CITY OF FRANKLIN  
PLAN COMMISSION MEETING\*  
FRANKLIN CITY HALL COUNCIL CHAMBERS  
9229 W. LOOMIS ROAD, FRANKLIN, WISCONSIN  
AGENDA  
THURSDAY, AUGUST 6, 2020, 7:00 P.M.

RE: Site Plan amendment application – 2950 W Statesman Way

Below are comments and recommendations for the Site Plan amendment application submitted on June 16, 2020, to allow for additional parking and a grilling/picnic area in the Statesman Apartments development.

## TREE RELOCATION AND SNOW STORAGE PLAN

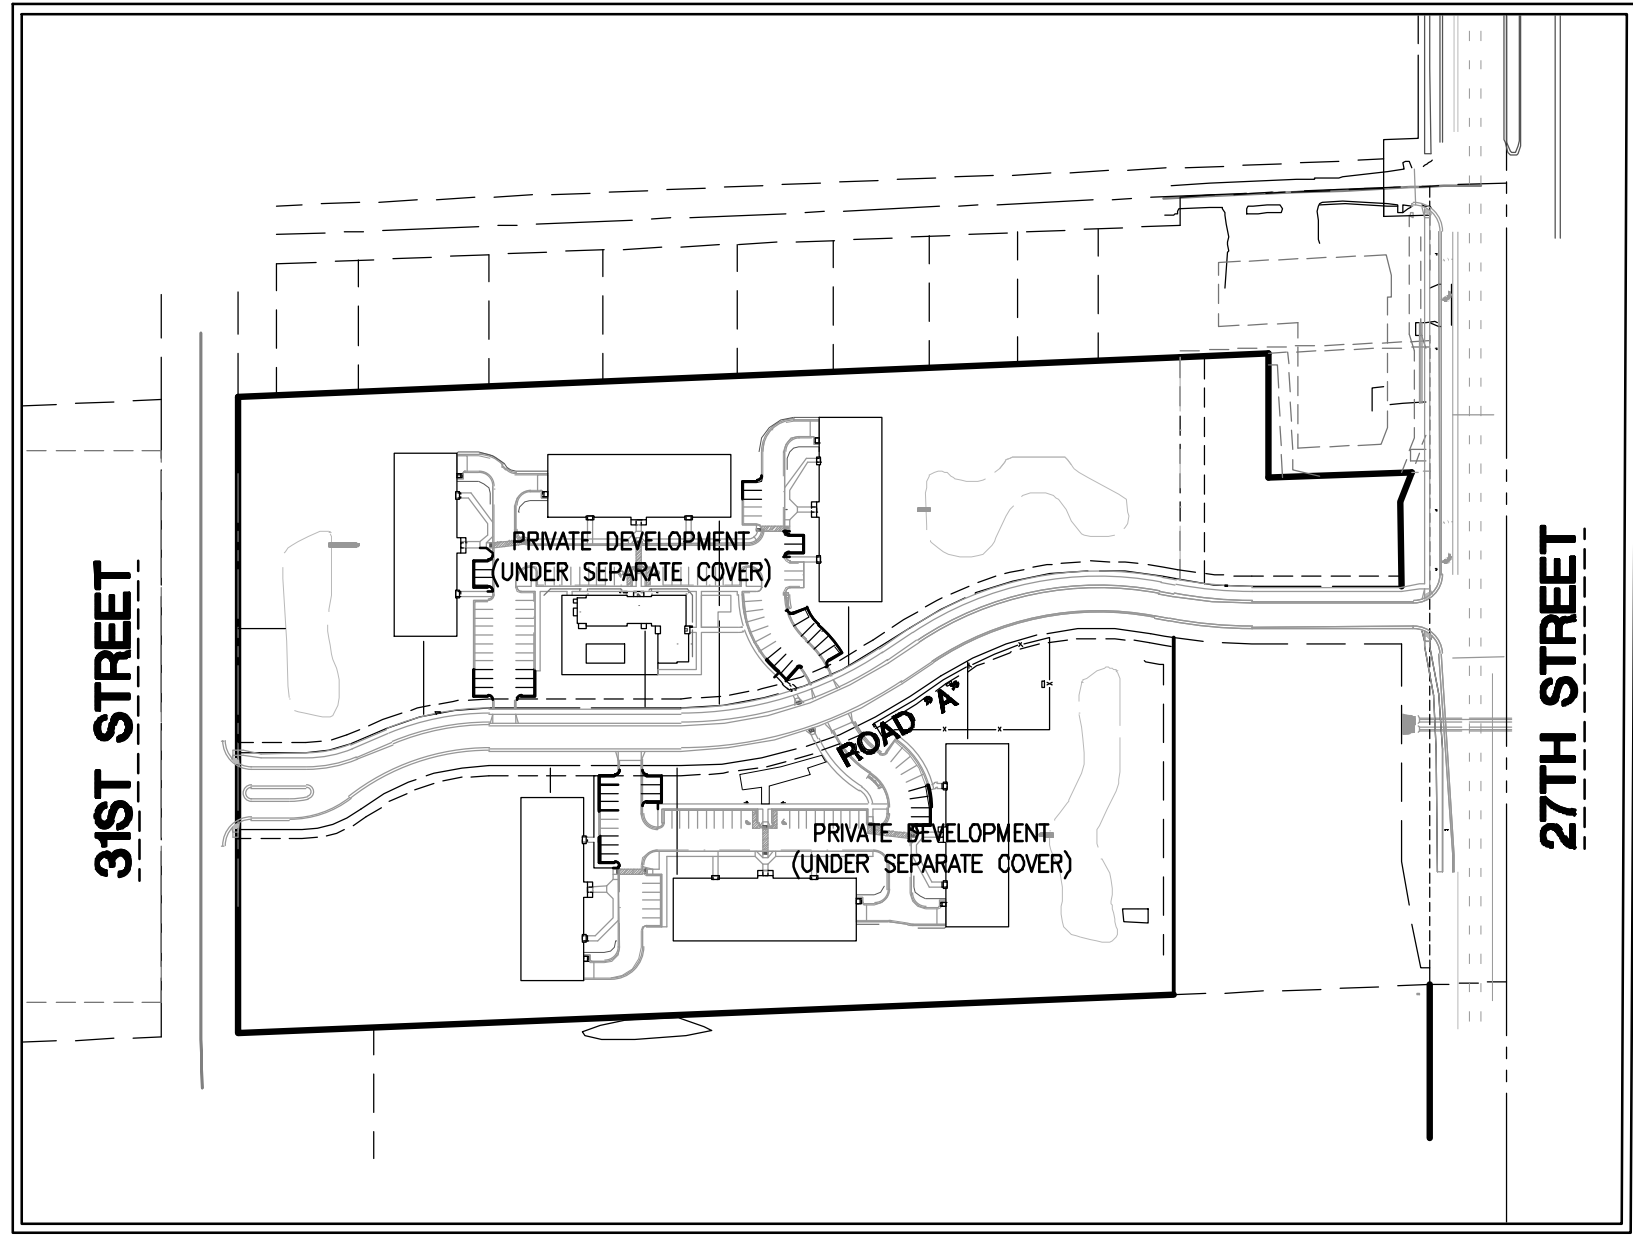
5. As the required landscaping for multi-family developments is based on the quantity of dwelling units (UDO §15-5.0302), no additional landscaping is required for this project. However, any landscaping feature impacted by the additional parking needs to be relocated or replaced. Please provide a landscape plan.

7. A snow storage plan is required per UDO §15-5.0210(B), refer to the noted section for snow storage standards. Please include the area intended for snow storage and the total area for surface parking including access drives (in square feet).

Please see the Tree Relocation And Snow Storage Plan illustrating impacted plantings requiring relocation.

Please see the added Tree Relocation And Snow Storage Plan.

SHEET  
C-4  
C-7

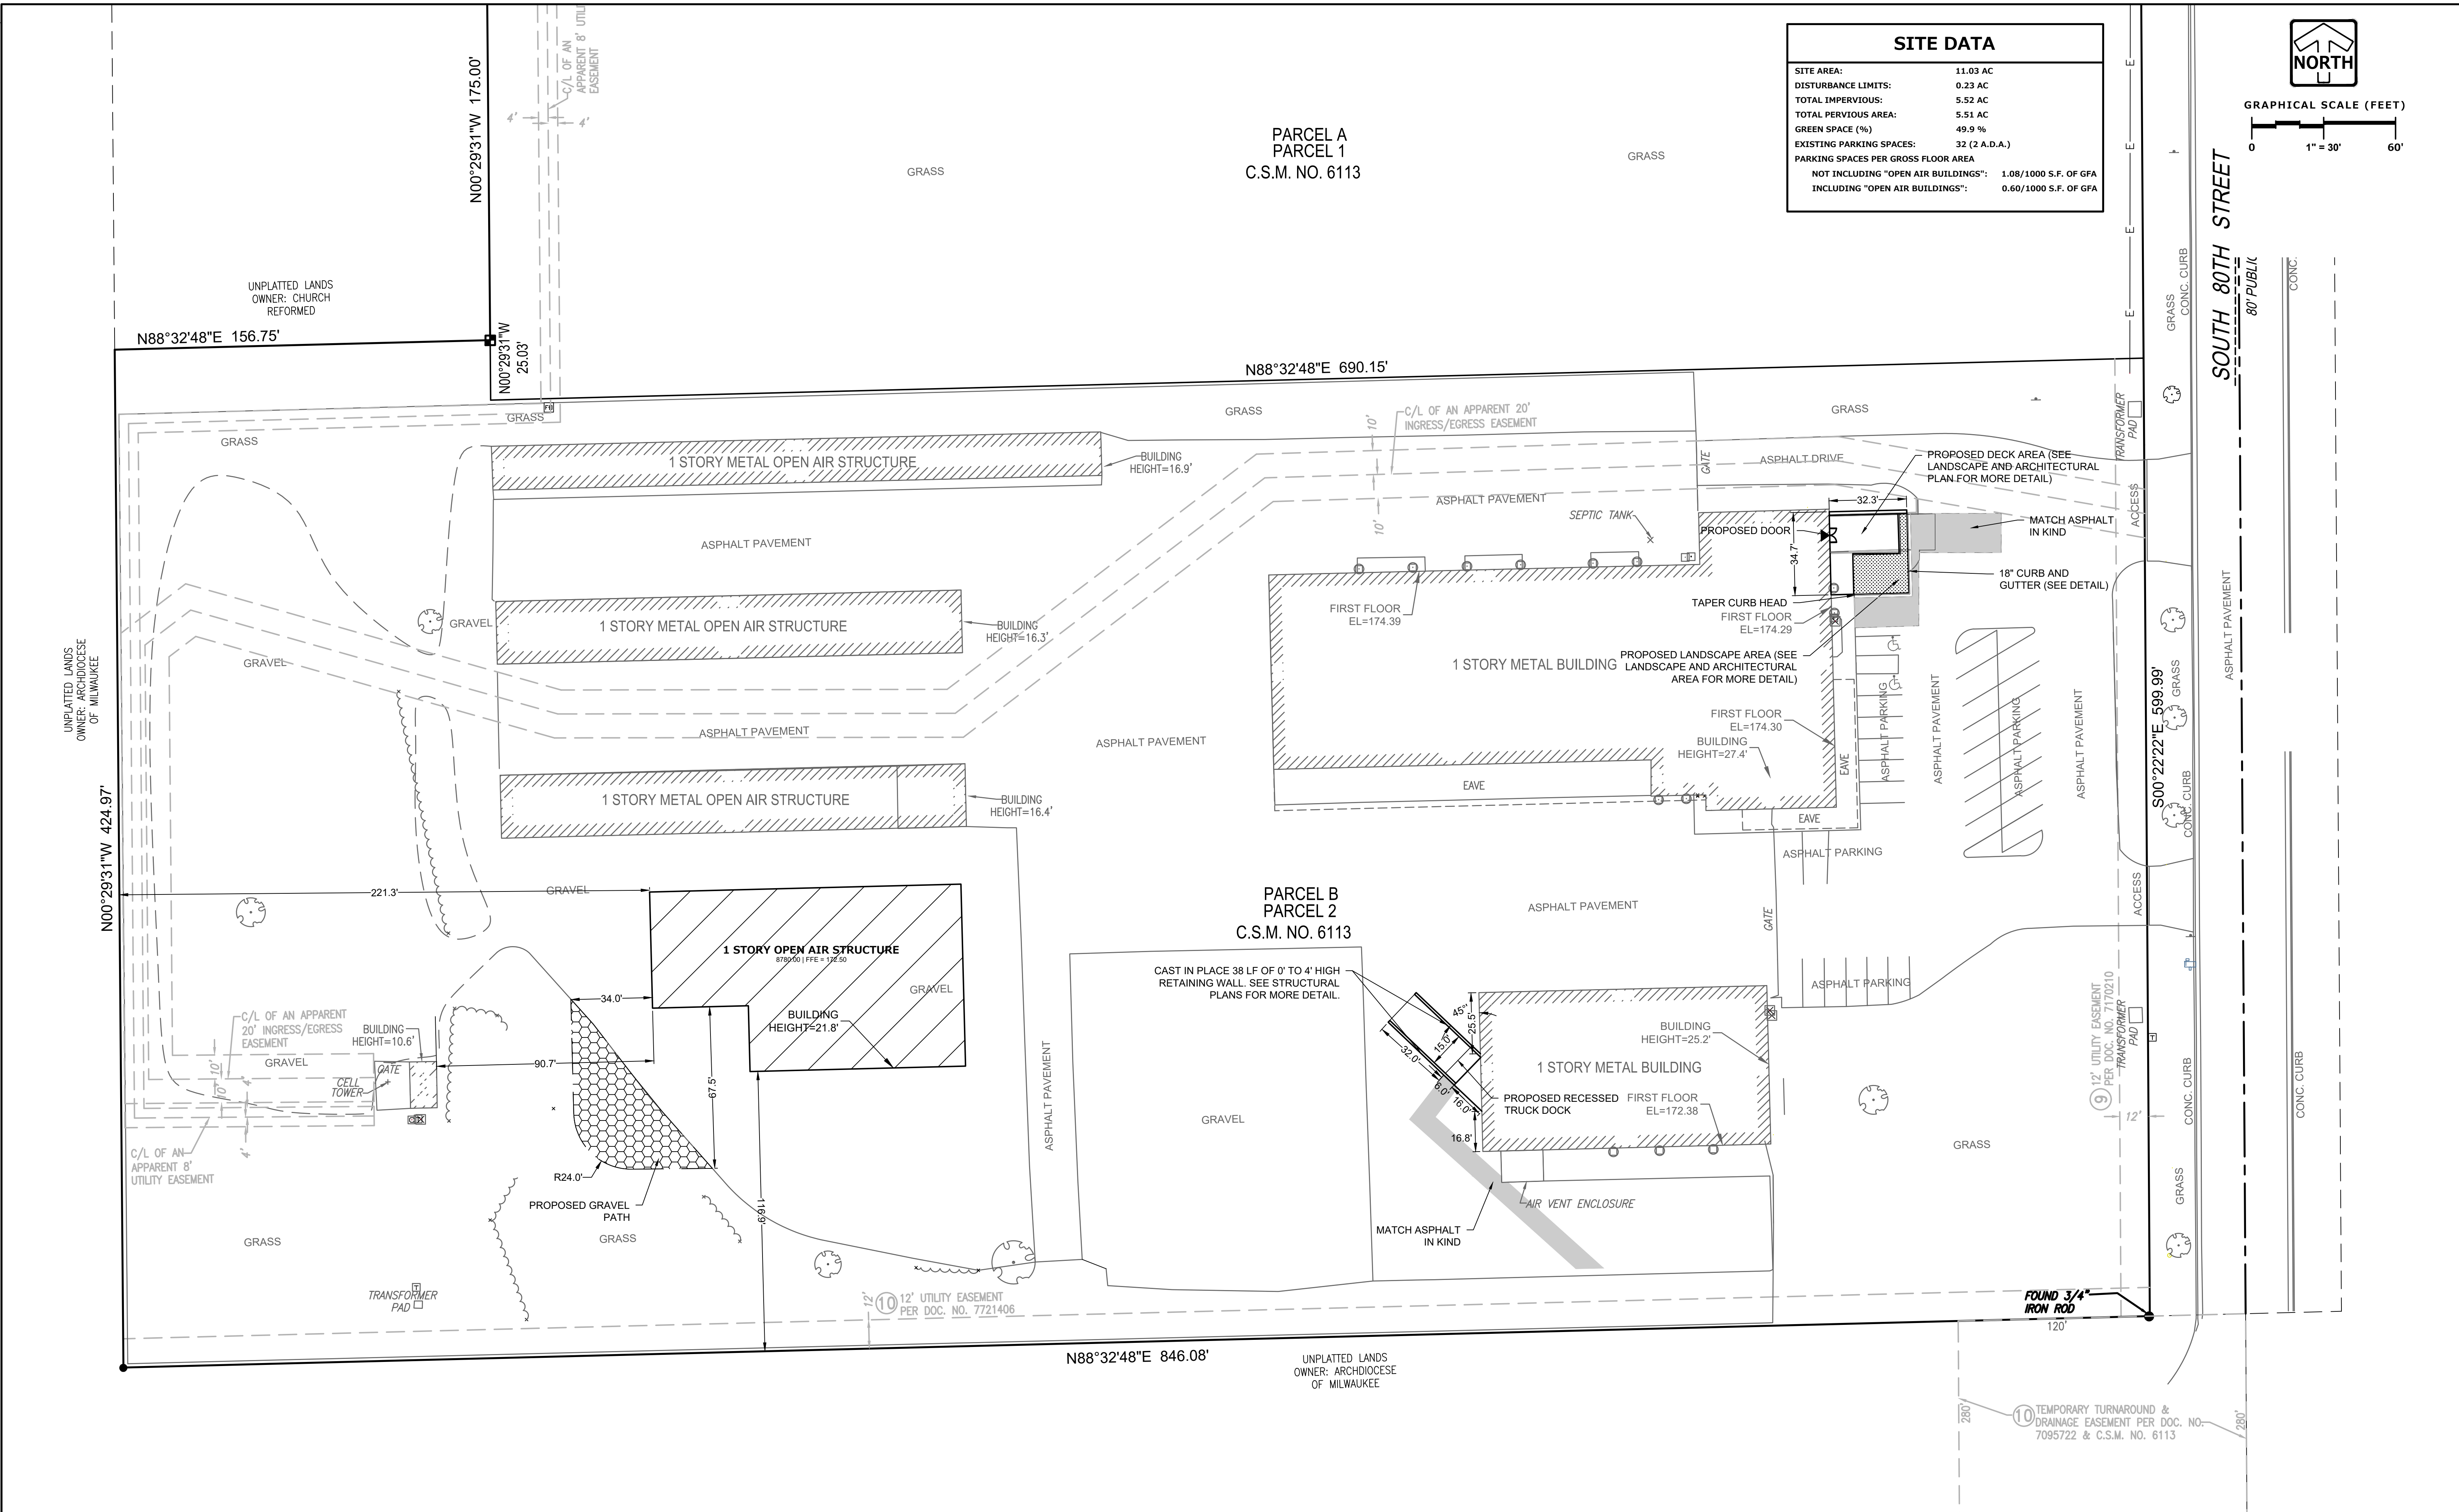
2. Please indicate the setback of the proposed open air storage building to the existing monopole tower.
  - **RESPONSE: A dimension between the building at the cell tower and the nearest face of the proposed open air storage building has been added to sheet C-4.**

3. There is a discrepancy between the project narrative and the proposed site plan (sheet C-4) regarding the floor area of the open air storage building: 12,000 sf or 8,780 sf, please clarify.

5. Please provide updated parking calculations based upon the gross floor area (GFA) of each use, see suggested parking ratios of UDO Table 15-5.0203:
  - **RESPONSE: Parking calculations for GFA have been added to the site data table on sheet C-4.**

- **Landscape Surface Ratio (LSR).** The ratio derived by dividing the area of landscaped surface by the base site area.
  - **RESPONSE: The LSR of this site is 0.50. A site data table has been added to sheet C-4 to reflect this.**

- **RESPONSE: Labels indicating the height and number of stories of the proposed open air storage building have been added to sheet C-4. Building elevations attached from Darnell Construction**
